UTAH DIVISION OF
SOLID & HAZARDOUS WASTE

CLASS 2 MODIFICATION

REQUEST NUMBER: TOCDF-MDM-02-0836

REQUEST TITLE: Froth Collection System for MDMs

CHEMICAL STOCKPILE DISPOSAL PROGRAM
MUNITIONS DEMILITARIZATION BUILDING
AGENT COLLECTION SYSTEM PHS-MDM-101
PIPING & INSTRUMENT DIAGRAM

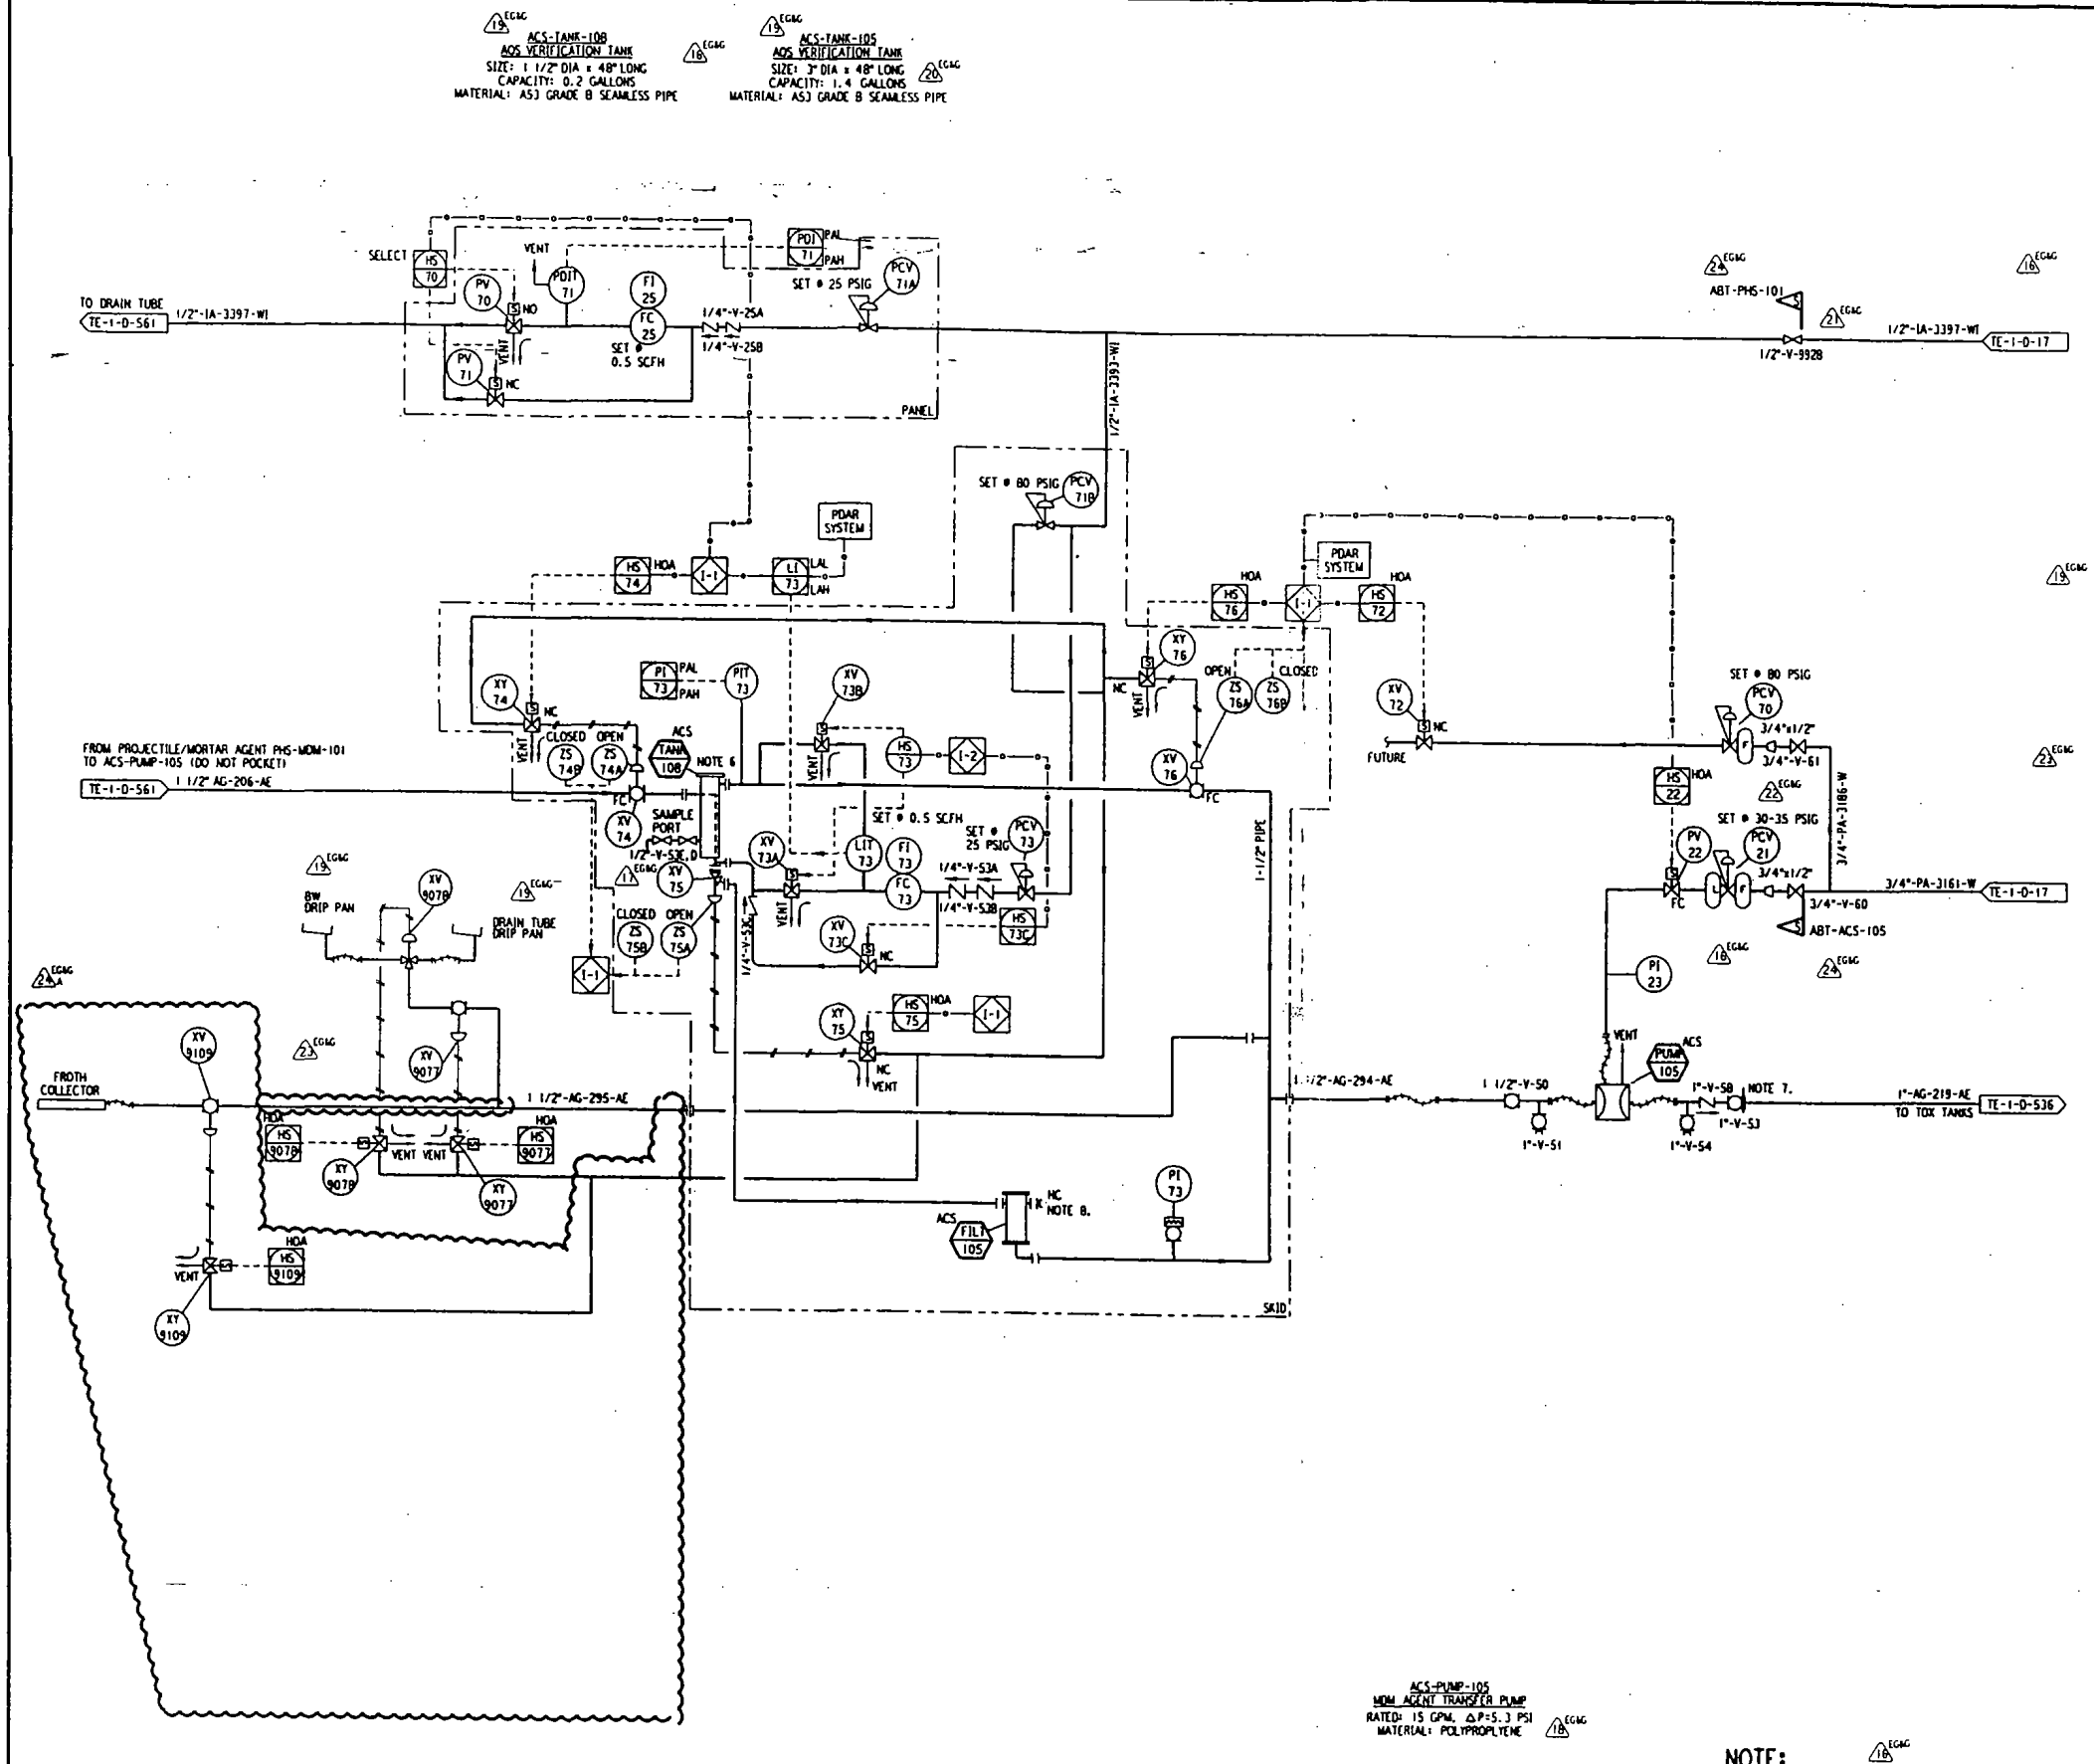
1) TE-1-D-521 Sheet 1 of 1, Agent Collection System PHS-MDM-101
2) EG-01-D-521 Sheet 1 of 2, Agent Collection System PHS-MDM-102
3) EG-01-D-521 Sheet 2 of 2, Agent Collection System PHS-MDM-103

19 EG&G ----- FUTURE FROTH COLLECTION FOR HD CAMPAIGN

ASSEMBLY DRAWING
FROTH COLLECTION
MDM

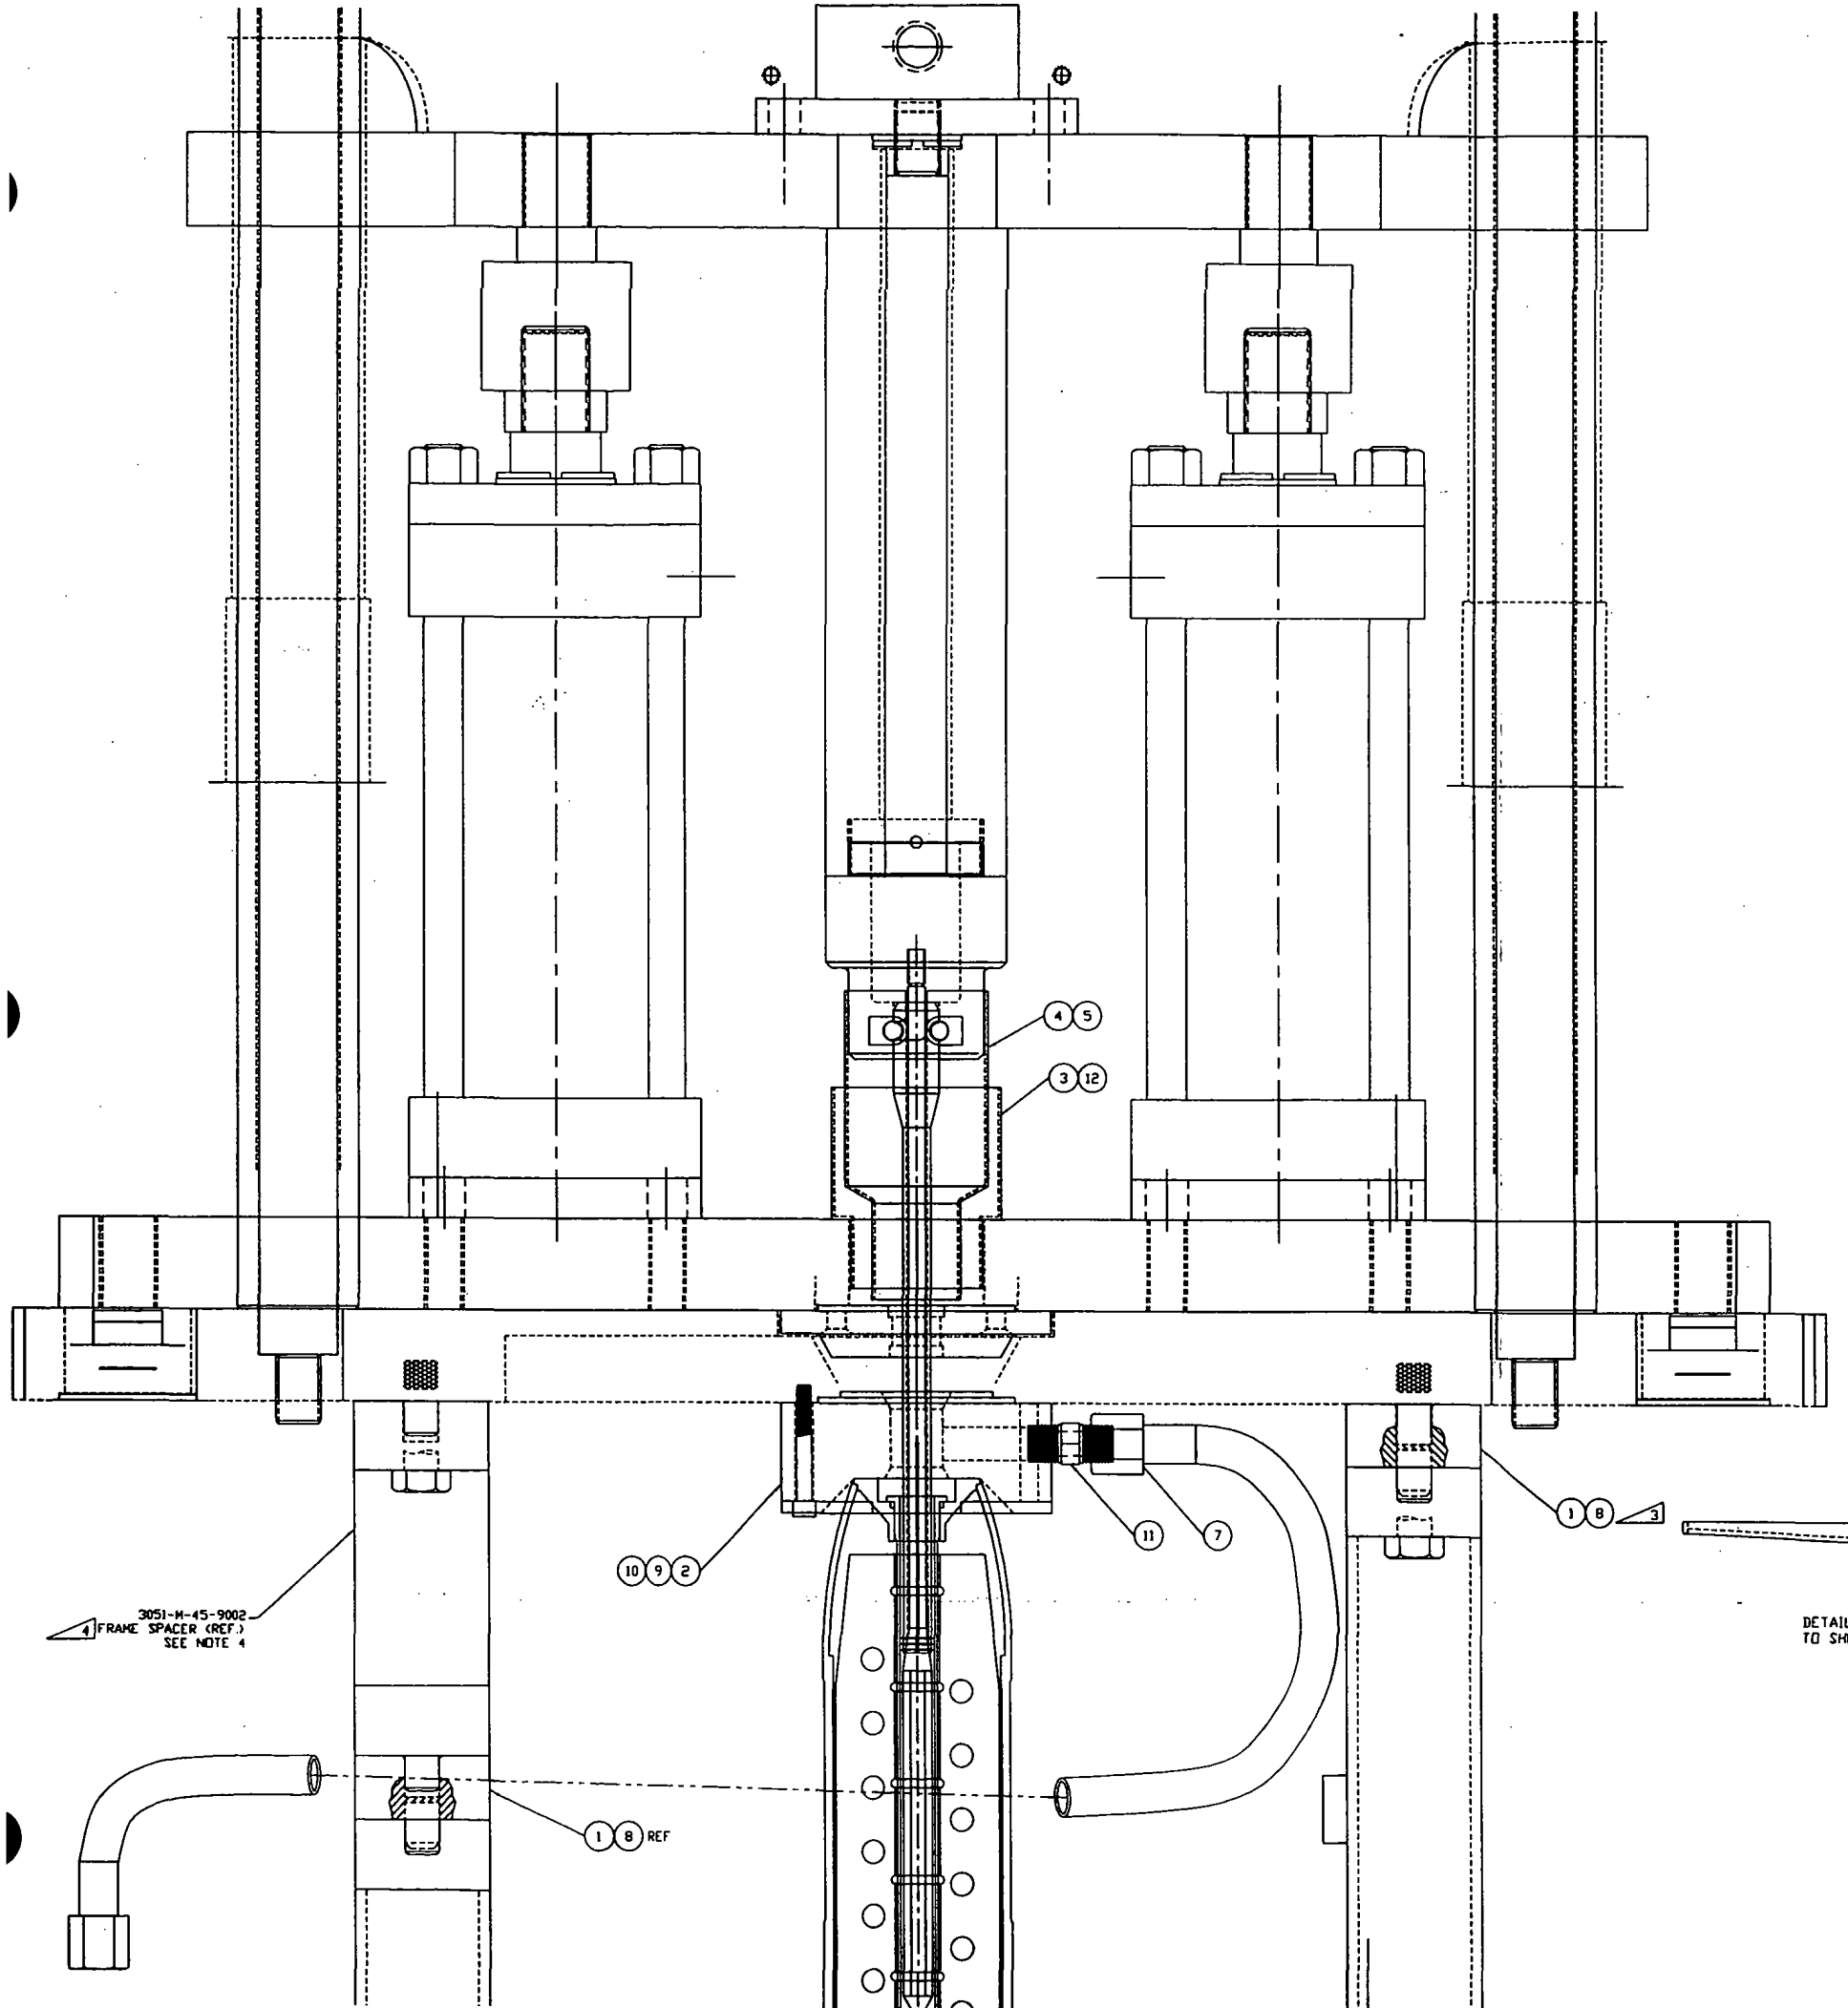
The MDM froth collection system consists of six key elements:

DETAIL OF DRIP PAN ASSEMBLY
TO SHOW NEW CYLINDER HANGER

MODIFIED STOP PLATE 4.2 MORTAR
FROTH COLLECTION SYSTEM
MDM PUNCH & DRAIN STATION

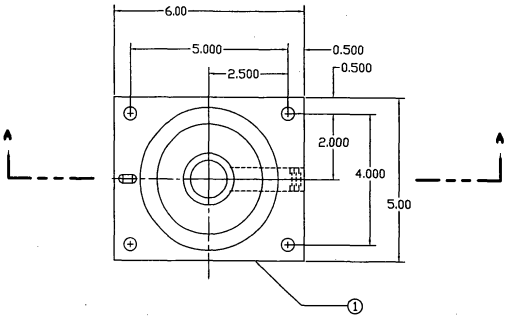
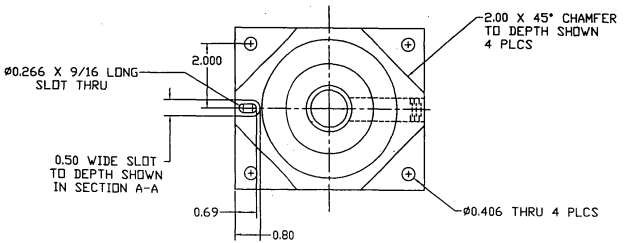
1) A modified stop plate
   The mortar is raised by the lift cylinder until it is firmly in contact with the stop plate, which holds the mortar's body down while the burster well is removed upward. The existing stop plate will be replaced with a new stop plate with a radial hole bored and tapped to provide a suction pathway from the inner hole that immediately surrounds the burster well press fit. The radial hole thus is at the location where the froth will begin to exit the mortar. To accommodate the radial hole, the new stop plate will be made thicker than the previous stop plate.

FROTH DAM AND FROTH CYLINDER HANGER MDM

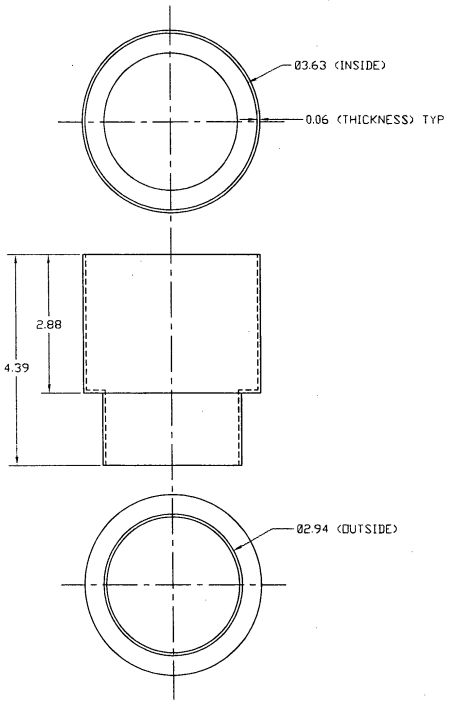
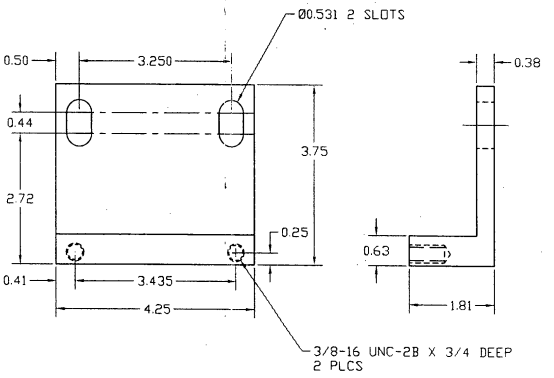
2) A froth dam
   The froth dam is an open-ended canister facing upward that will serve as a temporary chamber accumulating froth until the suction is capable of drawing the froth away into the agent collection system.

5) A modified drip pan cylinder hanger bracket
   Because the existing drip pan hydraulic cylinder is mounted to the pull and drain framework, which will be raised, a lengthened cylinder mounting bracket will be required to account for the modified overall dimensions.

MDM FROTH SHIELD FOR 4.2 MORTAR

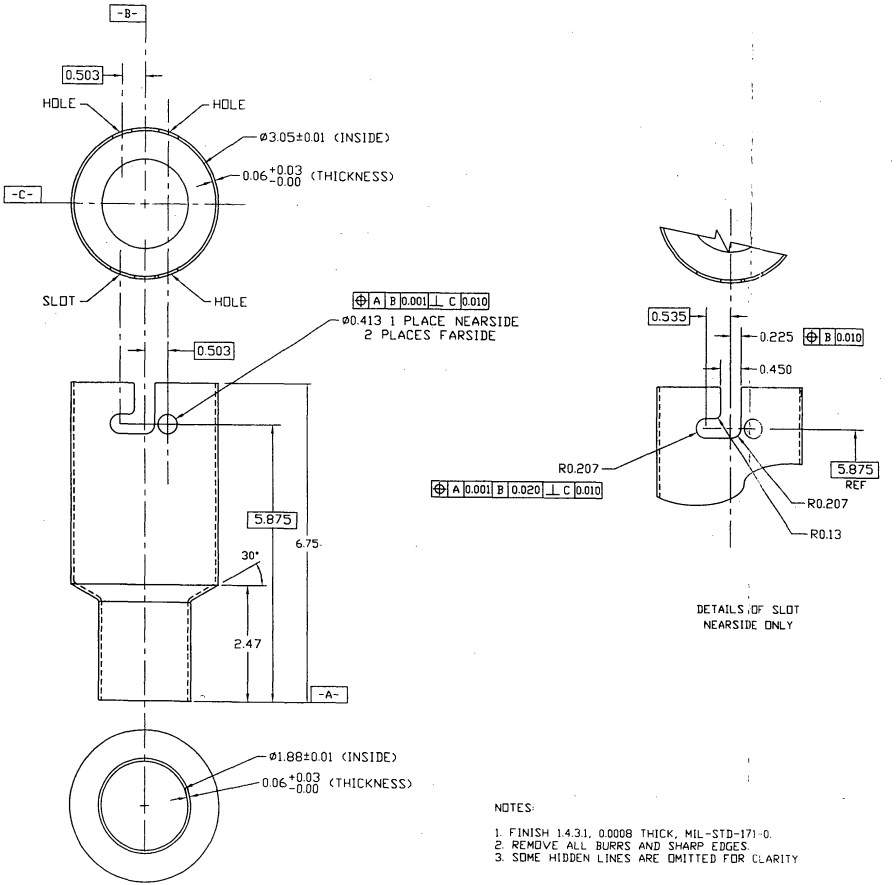
3) A froth shield
   The froth shield serves to redirect froth ejected out of the mortar downward into the froth dam.
4) Frame spacer plates
   Due to the additional thickness of the stop plate, the entire pull and drain framework will need to be raised an additional 1-3/8" to restore the mortar's overhead clearance.
